## Whittlesea Planning Scheme Amendment C241

## Shenstone Park Precinct Structure Plan

**Date of Statement:** 28 October 2020

**STATEMENT TO PLANNING PANELS VICTORIA BY JASON LEE WALSH, TRAFFIC ENGINEER**

Figure 3: Future Urban Structure Plan with Subject Land (Amended October 2020)

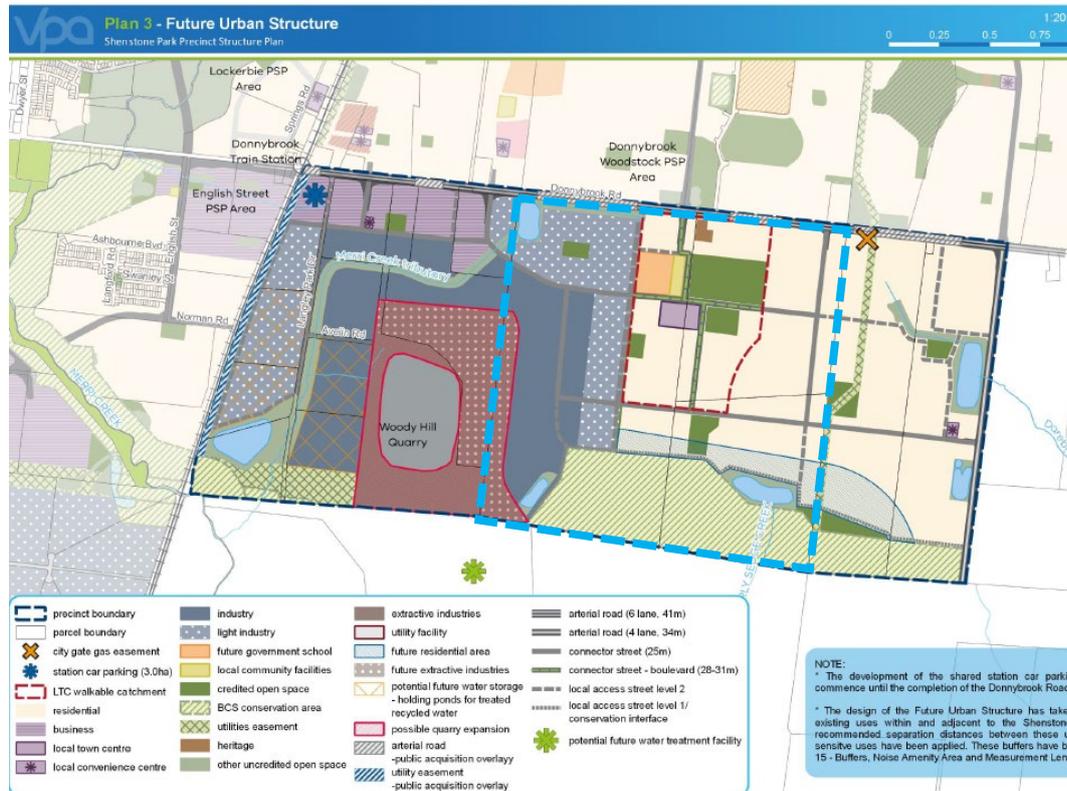
- 37 Beyond the main east-west connector (IN-06), interconnectivity between sites and access to parks can be established through local access streets.
- 38 From a traffic perspective, the siting of the Local Town Centre would be best placed at the intersection of the extension of Patterson Drive (IN-03) and the east-west connector (IN-06), as this provides the most convenient accessibility from the north and east.

- d) From a traffic perspective, the Local Town Centre is most appropriately sited at the intersection of the east-west connector and north-south connector (extending from IN-03).

Figure 4: Street Network Plan with Subject Land (Amended October 2020)

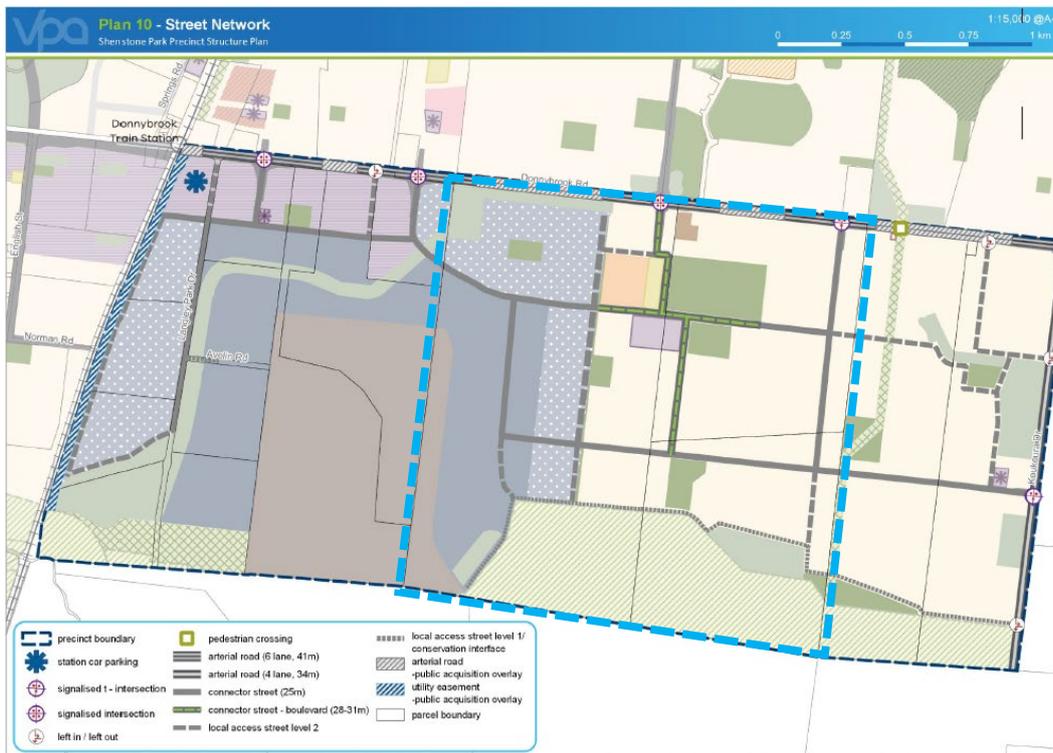
- 31 The north-south connectors should extend through in a logical manner through to the southern east-west connector.
- 32 The eastern most north-south connector (from IN-04) provides this convenient connection, however the central east-west connector (from IN-03) does not. It contains several turns in its connectivity to the south.

- 33 In my view this connector should provide a more direct connection to the south via straightening the road, and an ease of connection to IN-06 (Koukoura Drive).

- 34 The east-west connector roads are over prescribed in my opinion. The depth of the PSP from Donnybrook Road to the conservation area is in the order of 1,200 metres in the western portion of 960 Donnybrook and 1,400 metres in the eastern portion of 1030 Donnybrook Road.

- 36 In consideration of the depth of the PSP and constrained connectivity, it is only necessary to provide a single east-west connector road, and it should be approximately central to Donnybrook Road and the conservation interface road. The road should also conveniently connect with Koukoura Drive at IN-06.

- 56 Based on the preceding assessment, I am of the view that:
- a) The siting of IN-04 is appropriate.
  - b) The central north-south connector (extending from IN-03) should be straightened with the turns removed.

- c) There is only a need for a single east-west connector, and it should provide a convenient connection to IN-06, and also have a convenient connection to the connector extending from IN-03.

Figure 7: Proposed PSP Precinct Infrastructure Plan (Grey Hatching shows Proposed PAO Area)

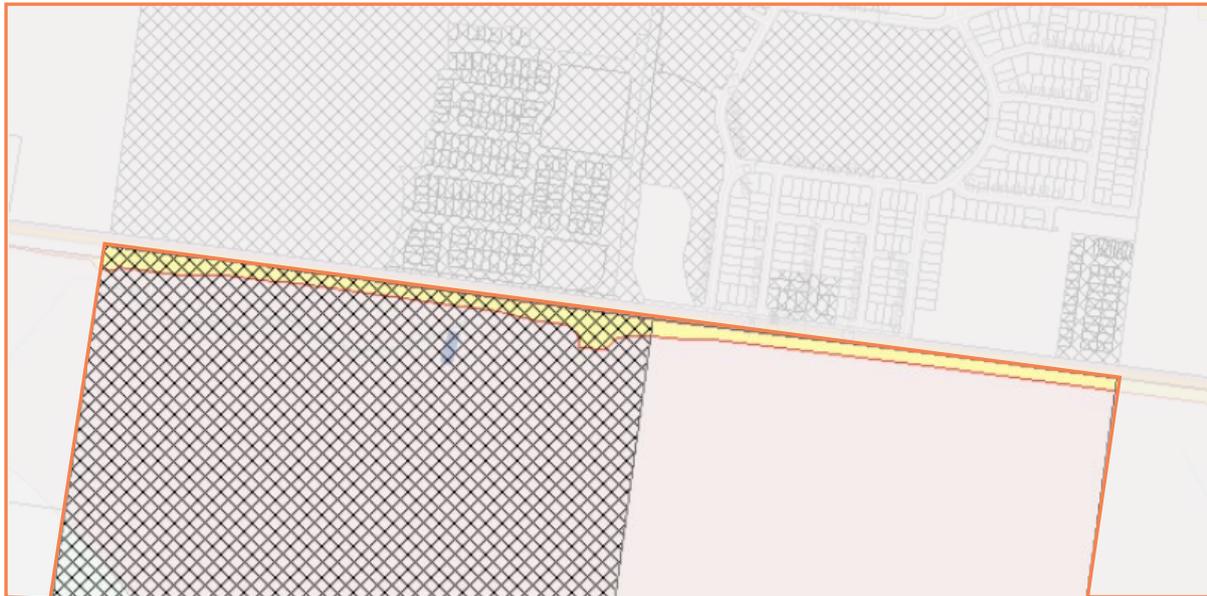
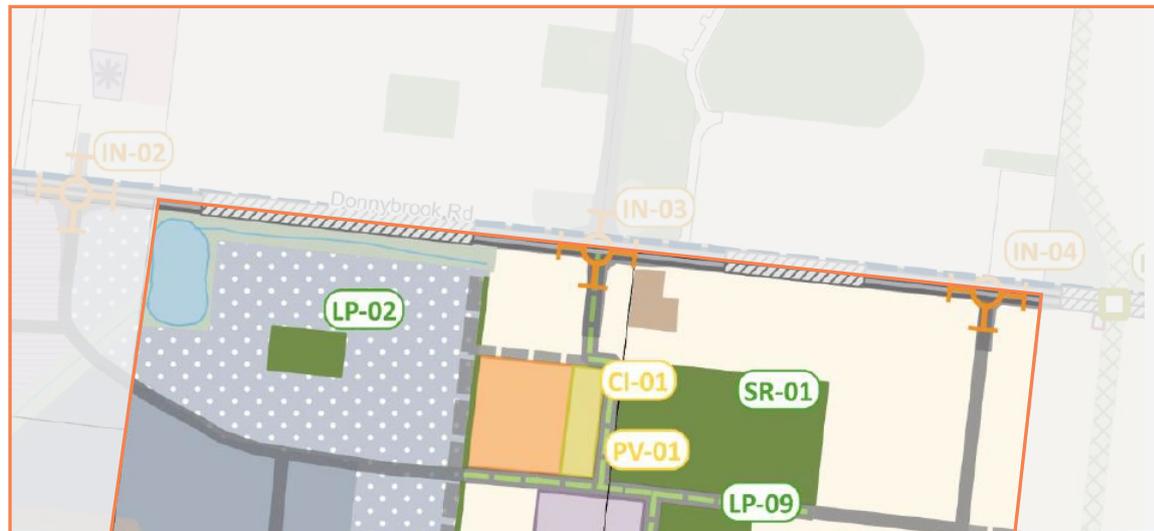
- 53 The areas do not match. It seems the VPA is proposing to remove part of the existing PAO as it relates to the extents of IN-02, IN-03 and IN-04.
- 54 I presume this is proposed to obviate the responsibility of the Department of Transport to acquire land associated with the PSP intersections, despite that land being previously identified as required for the duplication of Donnybrook Road.
- 55 Plans and particulars should be provided by the VPA to allow review of the PAO amendments.

- h) Better particulars should be provided to allow assessment of the proposed changes to the PAO along Donnybrook Road.
- 57 I have made all the inquiries that I believe are desirable and appropriate and there are no matters of significance I regard as relevant, which to the best of my knowledge, have been withheld from the Panel.
